### ADDENDUM NUMBER ONE – April 29, 2013

Project:	Guilford County Schools Hairston-Falkener Autism Classroom Building - TECHNOLOGY 400 Oferrell Street Greensboro, North Carolina 27401
Owner:	Guilford County Schools
From:	Efird Sutphin Pearce & Associates, PA 310 East Sycamore Street, Suite A Greensboro, NC 27401 Phone (336) 273-0083 Fax (336) 574-1916

Sheet E1.0 - Electrical Lower level Floor Plan - Power

RFI Number: 036

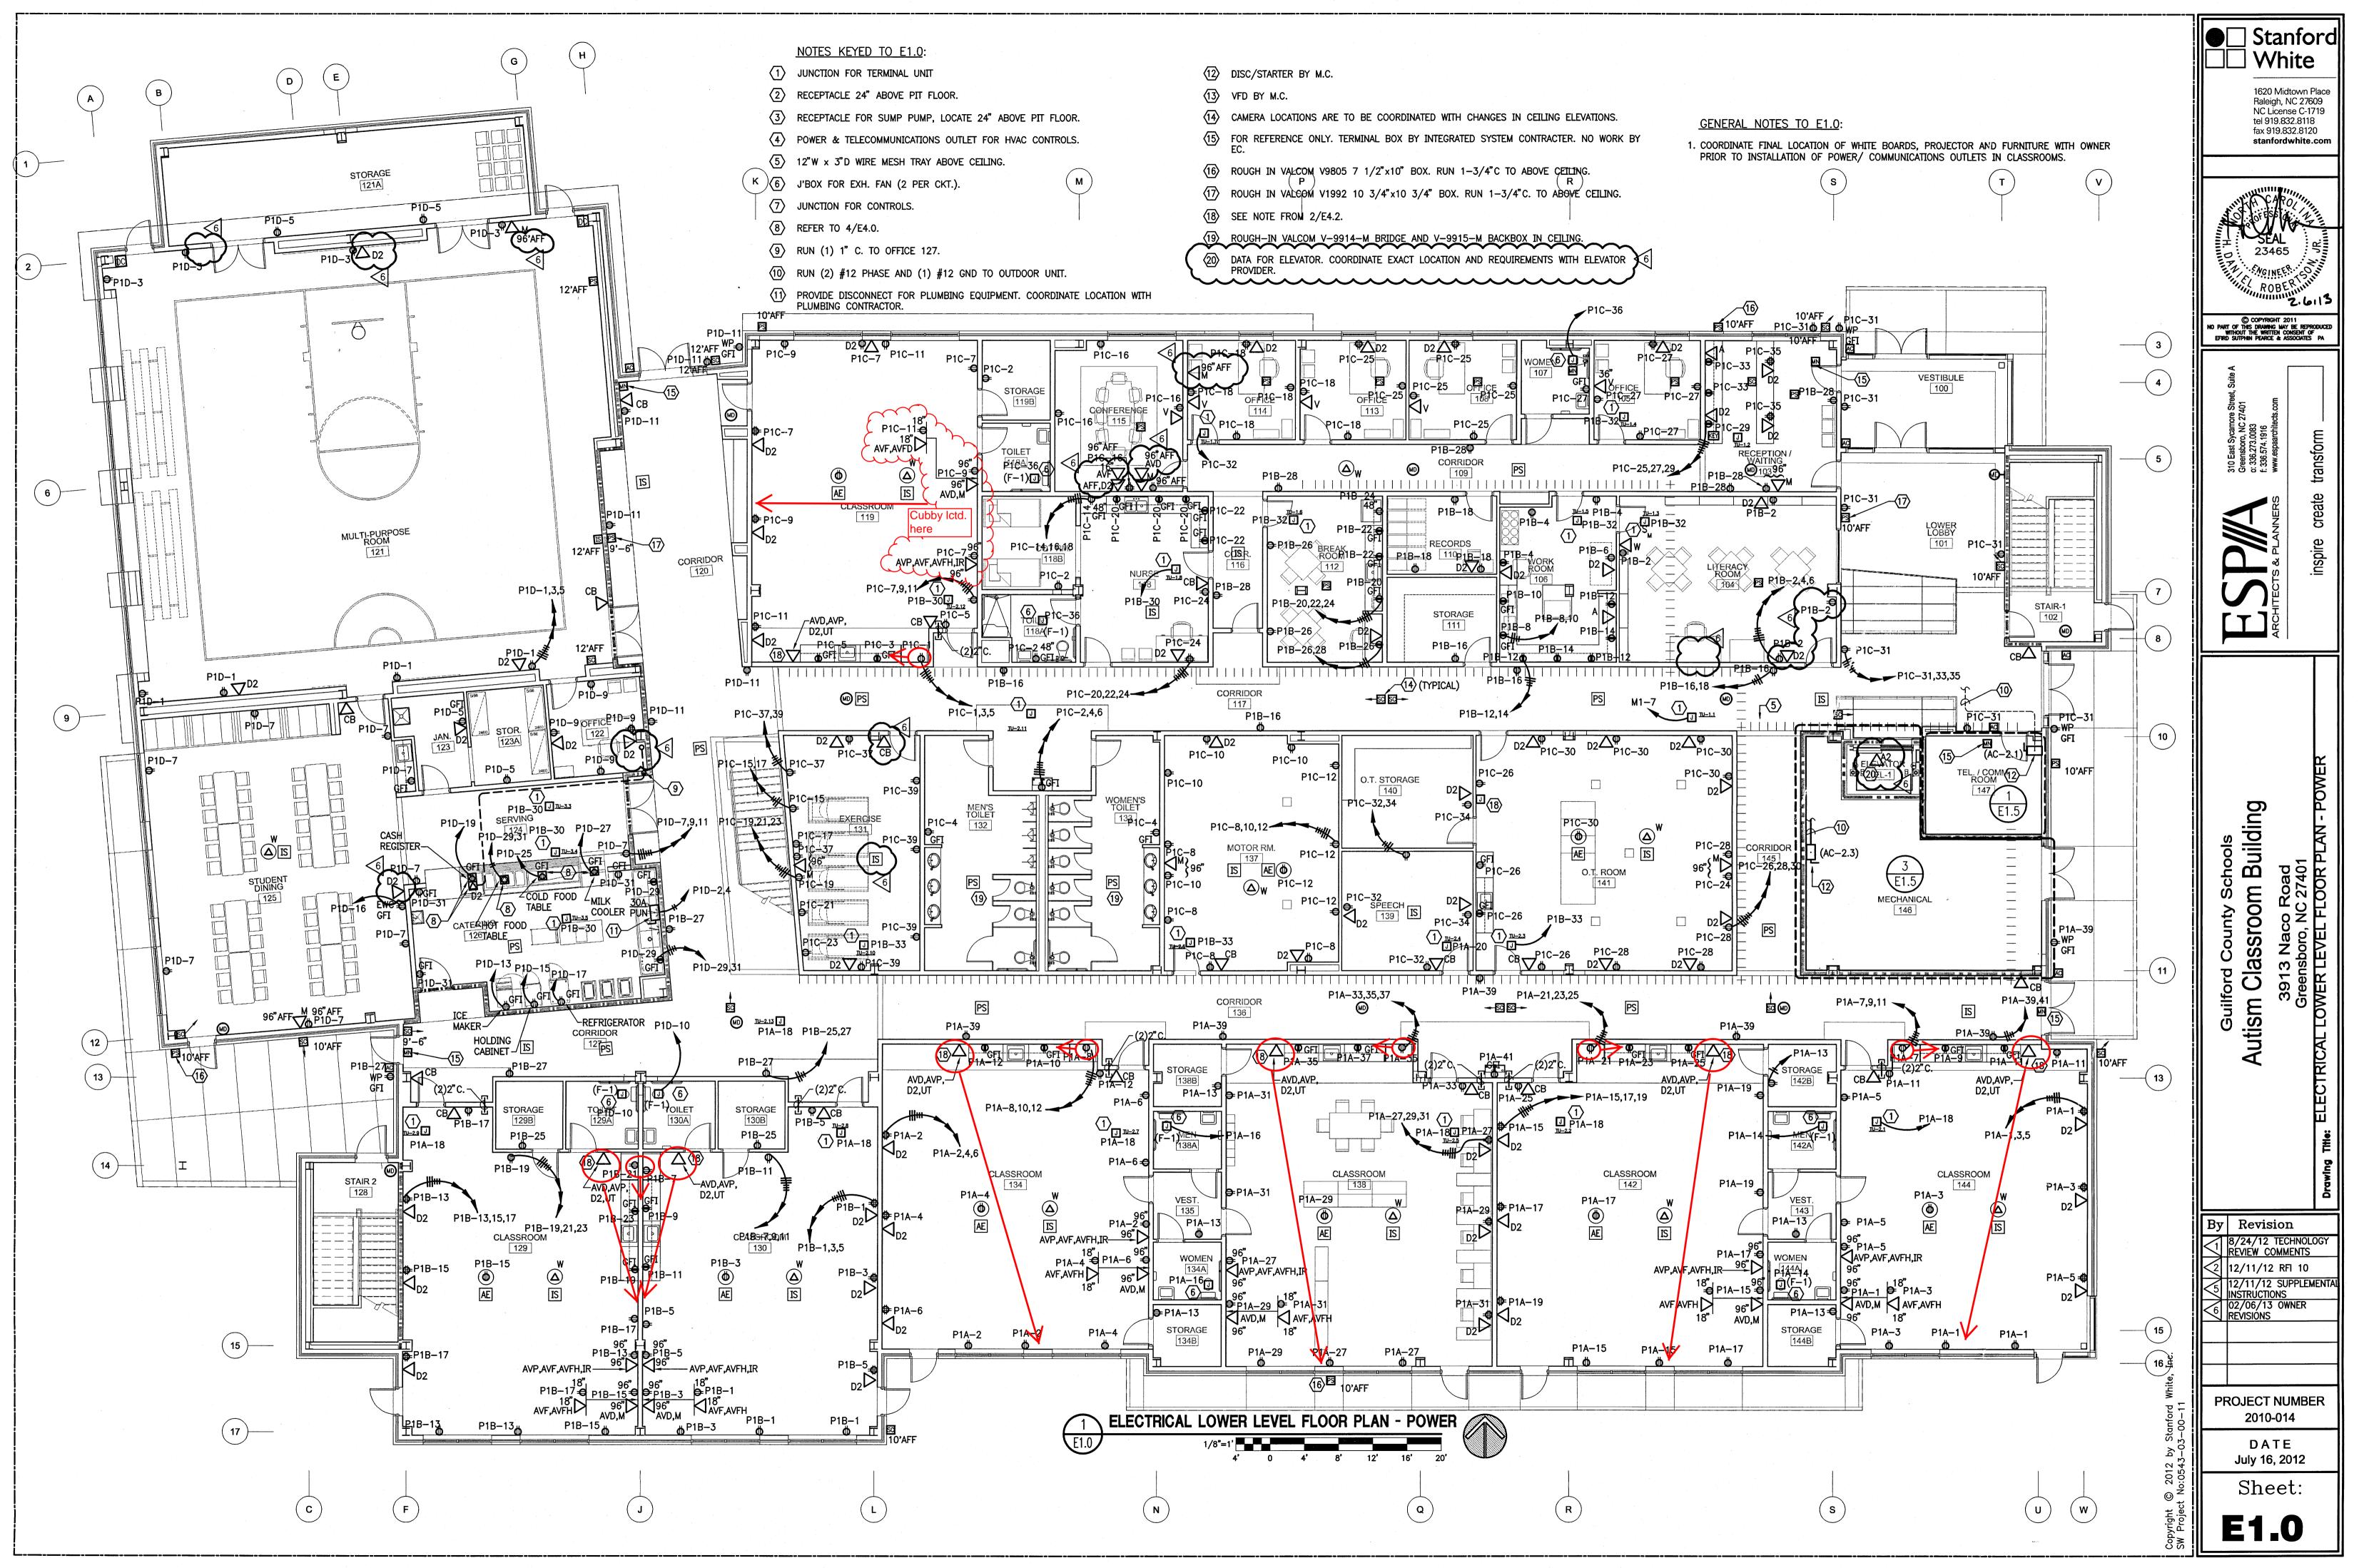
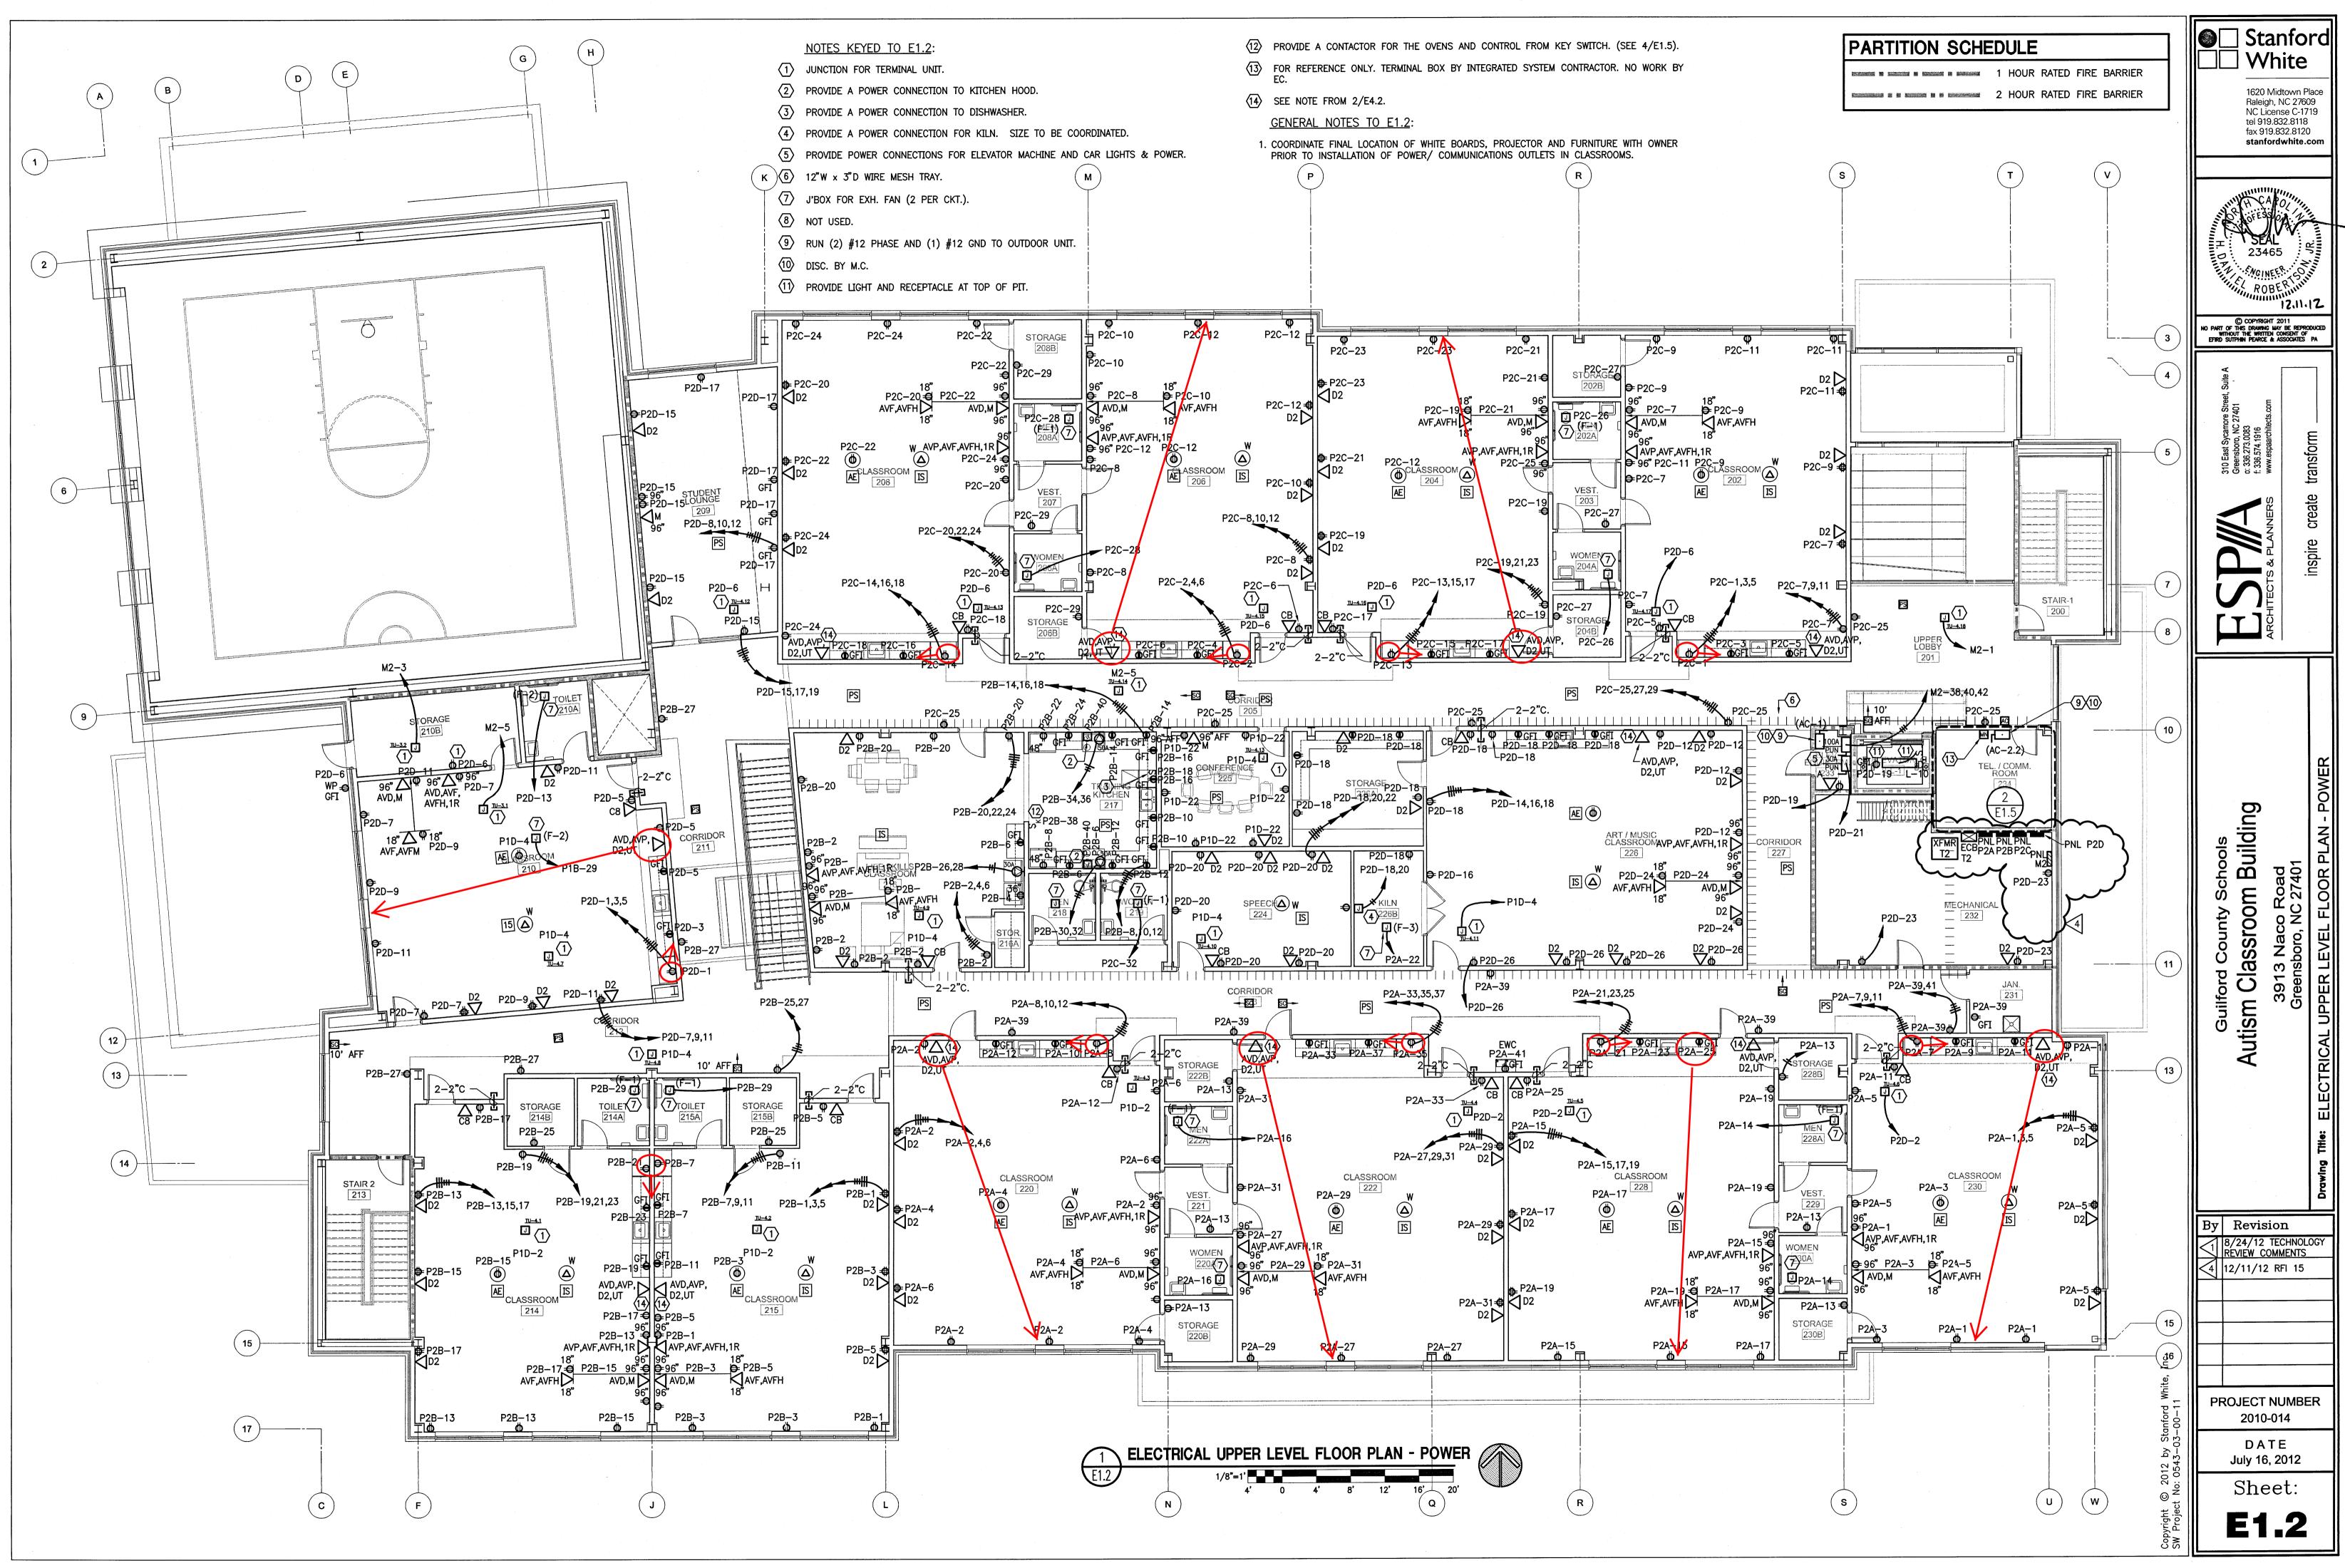
The engineer has expressed concern for the data outlet beside the GFI in classrooms 119, 129, 130, 138, 142 and 144. Plan E1.0 shows it at standard height, Sheet 3/A5.3 shoes the AV equipment in top cabinet. Also, will it need an outlet?

In reference to the above listed project, we are hereby requesting a clarification, determination and/or information concerning the following: **The engineer has expressed concern for the data outlet beside the GFI in classrooms119,129,130,138,142,144 ,plan E1.0 shows it at standard height, Sheet 3/A5.3 shows the AV equipment in top cabinet, Also will it need an outlet?**

Although the plans indicate a traditional AV cabinet, in two different locations on Sheet E1.0 and A5.3, there will not be physical cabinet. GCS Technology has indicated that the AV equipment will be installed with the teacher's desk. With that in mind, the location of the data outlet (AVD, AVP, D2, UT) near the casework should be relocated. The receptacle that is indicated behind the tall cabinet in each classroom should also be relocated to above the adjacent counter. Refer to the attached PDF drawings for the proposed locations of these devices.
